Rezoning Application: Zoning Hearing Master Date: BOCC Land Use Meeting Date:

PD 23-0041 June 20, 2023 August 8, 2023 July 18, 2023

Development Services Department

1.0 APPLICATION SUMMARY

8.0 PROPOSED SITE PLAN (FULL)

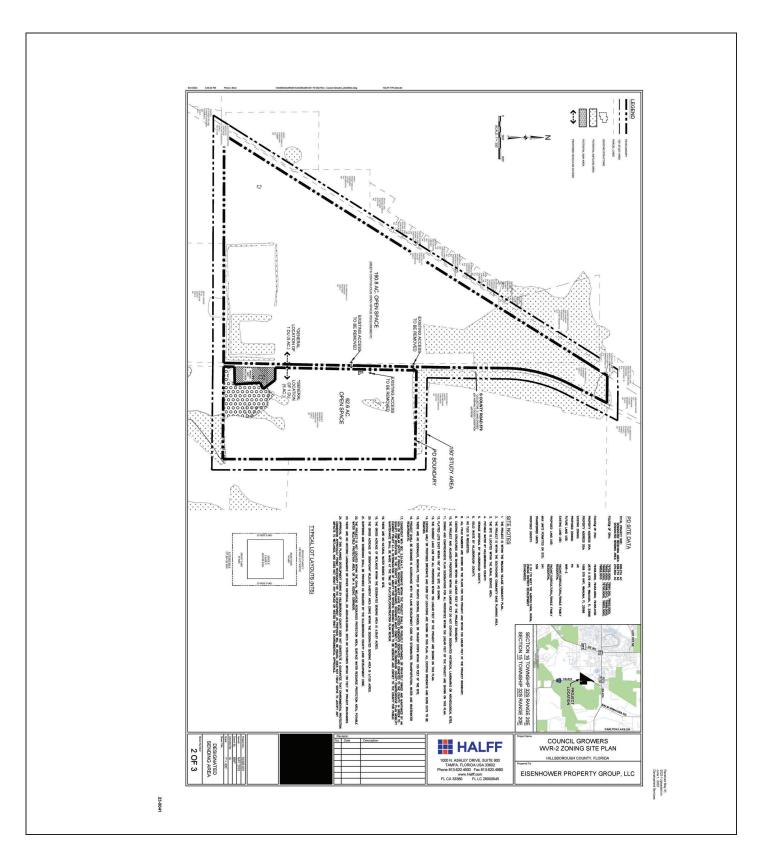
- 1. Typical Lot Layout shown on Sheet 2 of 3 (Sending Area) to be modified to be consistent with condition 9.
- 2. Typical Lot Layout for the Civic Building Lot Type to be provided on Sheet 3 of 3.

- 3. Development Standards table and Typical Lot Layouts to correct "Single-Family Detached" to "Standard House."
- 4. "Number of Units" column in the Development Standards table to reference the 10% minimum 40% maximum for the Cottage House Lots, Rowhouse Lots and Apartment House House Lots; to reference the 10% minimum to 50% maximum for the Standard House Lots (combined); and to reference the 10% minimum to 40% maximum for the Civic Building Lot Type as not applicable.

- 7. Development Standards table to include the number of stories (1-4) for Civic Building Lots.
- 8. Development Standards table to provide the minimum-maximum lot sizes and minimum-maximum lot widths for the Cottage House Lot Types (both or one size/width) and Standard House Lot Types (both types), as provided in the Lot and Primary Structure Requirements by Lot Type (LDC Section 3.24.08).

- 9. Development Standards table to provide the number stories (1-4) for the Civic Building Lot.
- 9. Note #4 on Sheet 3 of 3 to replace "park" with "recreation."

- 10. The 8 acre and 4.5 acre "Internal Recreation Areas" to be re-labeled "Community Benefit Park and Internal Recreation Areas."
- 11. Community Benefit notations within the "Community Benefit Park and Internal Recreation Areas" to add Tier 2-7 to Tier 1-4.

- 12. "Note 6" to be removed from the 8 acre and 4.5 acre "Community Benefit Park and Internal Recreation Areas."
- 13. Tier 2-7 in the Community Benefits table in the PD Site Data to correct the internal recreation acreage from 12.5 to 2.5.

- 14. PD Site Plan Data to separate the required Internal Open Space acreage from the Community Benefits. Internal Open Space:

- 15. Proposed "Pedestrian and/or Multi-Use Trail access/stub-out" in the Legend to be modified to remove "Pedestrian and/or."
- 16. Site Plan to provide the following Site Note: Wetlands or other surface waters are considered Environmentally Sensitive Areas and are subject to Conservation Area and Preservation Area setbacks. A minimum setback must be maintained around these areas which shall be designated on all future plan submittals. Proposed land alterations are restricted within the wetland setback areas. Only items explicitly stated in the condition of approval or items allowed per the LDC may be placed within the wetland setback.
- 17. Prior to certification of the General Development Plan (GDP), the applicant shall revise Sheet 3 of 3 the GDP to:

APPLICATION NUMBE		23-0041	
ZHM HEARING DATE: BOCC LUM MEETING		ne 20, 2023 igust 8, 2023 <u>July 18, 2023</u>	Case Reviewer: Michelle Heinrich, AICP
	17.a	Block" and "Typical Neighbo	Pedestrian Thoroughfare" within the "Typical Residential rhood Center Block" portions of the site plan, as well as would suggest that such facilities could be permitted;

17.t	Residential") from the top of Public Right-of-Way – See Co	on, remove the reference to ("Residential and Non- f the section and change to top label to read "69' Min. onditions of Approval". Staff notes that as a proposed ese distinctions are meaningless in the TTM.

17.c		on, change the label reading "Typical Section for East of d "Typical Section for Berry Grove Blvd. Extension East of
	17.e		n, change the label reading "116' Min Right-of-Way" to ic Right-of-Way – See Conditions of Approval".

17.f	In the leftmost typical sectio	n, change the label reading "10' Utility, Landscape & tead read "10' Utility, Landscape, Hardscape & Public
	17.g		n, change the label reading "Typical Section for West of d "Typical Section for Berry Grove Blvd. Extension West o

17.ŀ	In both typical sections, char "12' Tier 1-1 Multi-Use Trail"	nge the label reading "12' Multi-Use Trail" to instead read '.
	17.i	In the rightmost typical secti read "10' Multi-Purpose Trai	on, change the label reading "10' Sidewalk" to instead I".

19.b Change the label within the "Rowhouse (Rear Loaded)" row and "Rear Setback (Min)" column from "3' Min. Garage Setback (May Be Attached or Detached" to instead read "3' Min. Garage

19.c	Add the text "Lot Type" within the b	•		
20.		<i></i>	hborhood Center" portion of the table with a new table		
-		eads as follows:			
		"Proposed Non-Residential Uses:			
		1,000 Student Maximum Non-Charte	er Public School (Grades K-5)		
			Recreation Uses (see above and Note 4)		
			sidential Uses within the Three Neighborhood Centers.		
			r Uses (300 attendees combined maximum); Church Uses		
(300 seats combined maximum); One (1) Flexible Market Space, and Government/Public					
		Service Uses (see Notes 3 and 5)."

20.a	Revise "Site Note" 3 to read "Neighb	orhood Centers shall be developed utilizing the Civic		
		Building Lot standards.			
	20.b	Add a new asterisk to the "Proposed portion of the table and add a footne Uses within the project are subject t	Density" and new "Proposed Non-Residential Uses" ote at the bottom of the PD Site Data Table which reads o trip generation caps which apply separately between the		
	20 -	Northern and Southern Receiving Ar

20.c	Add arrow symbology to the legend 18-1048 and label as "Access within	corresponding with the access arrows within adjacent PD Adjacent PD 18-1048".

21.	Add a new s	site note stating "Areas of additional	right-of-way dedication and conveyance, as well as		
Corridor Preservation are not shown due to the graphic scale. Such areas are present along the project's					
	CR 579 and	Saffold Rd. frontages. See conditions	s of zoning approval for additional information."

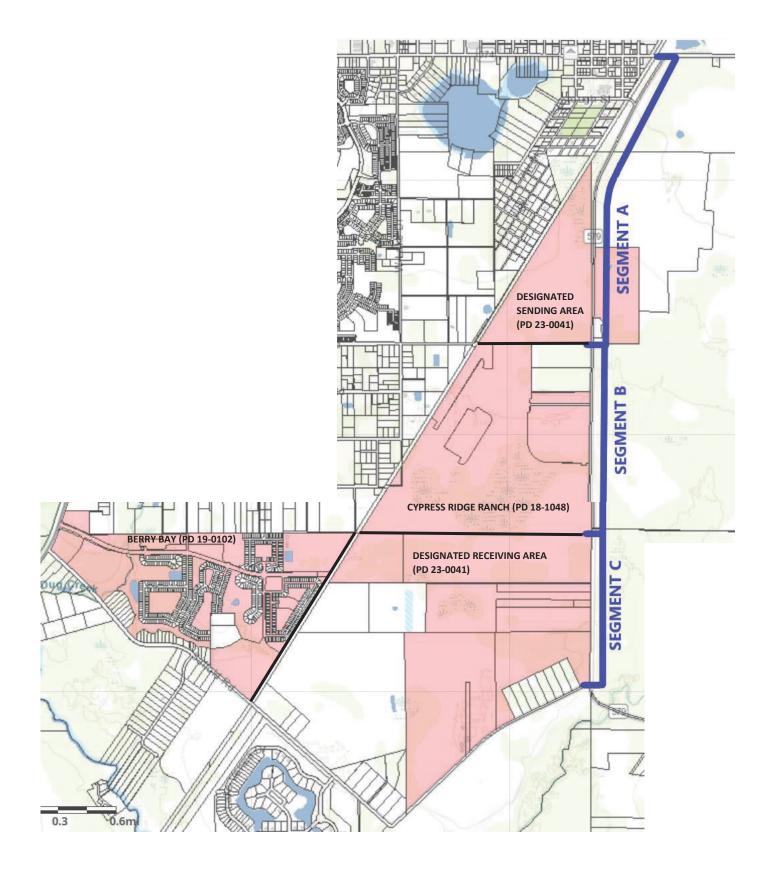
- 1. Right of Way The right of way along the segment of CR 579 varies between approximately 51 feet to 74 feet. As shown in Figure 1, the developer does own property along a portion of the segment and has committed to providing the right of way on each side of CR 579 to provide a total of 48 feet of right of way from the existing centerline of CR 579 within the limits of the property they own.

This segment is for the southern property line of the sending parcel to the northern property lines for the subject property, as shown in Figure 1. See Typical Section B for the section proposed along the segment of the roadway.

This segment is along the subject property frontage of Saffold Road, as shown in Figure 1. See Typical Section C for the section along the segment.

- 1. Right of Way The right of way along the segment of CR 579 varies between approximately 74 feet to 90 feet. As shown in Figure 1, the developer does own property along the portion of the segment and has committed to providing 48 feet of right way on the west side to accommodate the proposed improvements.
- 2. Lane Width TS-7 has 12 foot lanes. The existing lanes are 10 feet. This section proposes to maintain the existing lane width.
- 3. Shoulder TS-7 has 8 foot shoulders with 5 feet paved. The proposed section has 6 foot stabilized shoulder with five feet paved.
- 4. Sidewalk TS-7 has 5 foot sidewalk on both sides of the road. The proposed section provides a 10 foot multi-use path on the west side of CR 579. The Florida Design Manual Section 224.4 allows the standard 12 foot wide multi-use trail to be reduced to 10 feet due to limited right of way.

_____Approved

__Approved with Conditions
